HISTORIC PRESERVATION COMMISSION

ALTERATION TO A HISTORIC PROPERTY STAFF REPORT

Site: 1 Westwood Road c.1929 Somerville Museum
Case: HPC 2015.073 Westwood Road Local Historic District

Date of Application: October 28, 2015
Legal Notice: *Alter Westwood Road entry to meet ADA.*

Circa 1934 image of 1 Westwood Road
with Palladian window.

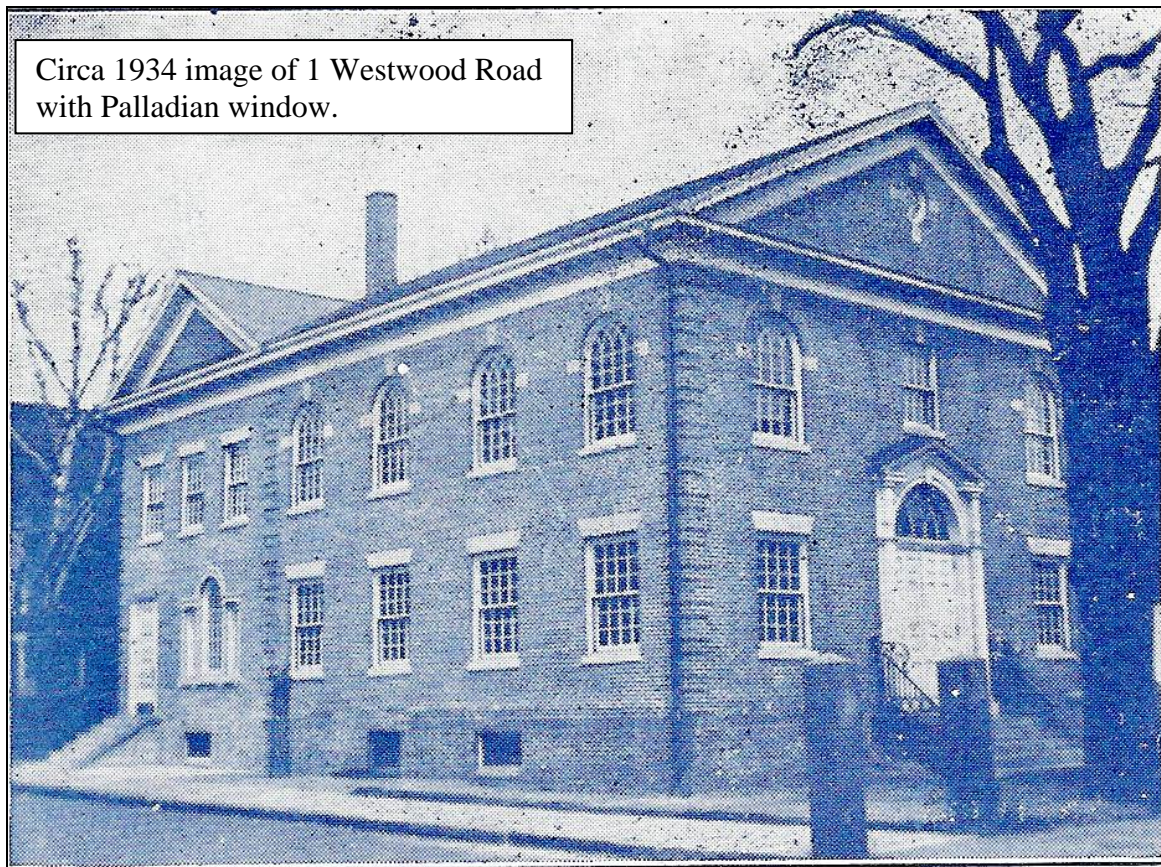
6. The Palladian window shall be relocated to the rear of the building facing the parking area as per MHC Preservation Restriction.
7. Historic Staff shall issue a sign-off upon completion of the project that this was done in accordance with the Certificate and approved plans and prior to the Somerville Historical Society receiving Inspectional Service Division sign off.

Rear of the Somerville Museum showing the approved location of the Palladian window as required by the MHC Preservation Restriction

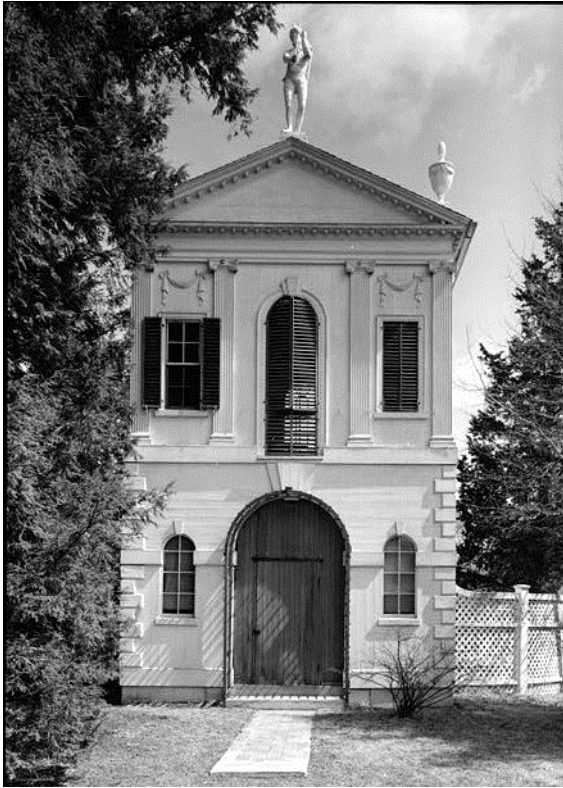
5. Other Provisions: The Palladian window, which will be crated and stored is to be reinstalled in a location approved by the Commission on the rear wall of the Somerville Historical Museum. Reinstallation of the window will occur at a future date when and if an elevator is installed in the Somerville Historical Museum.
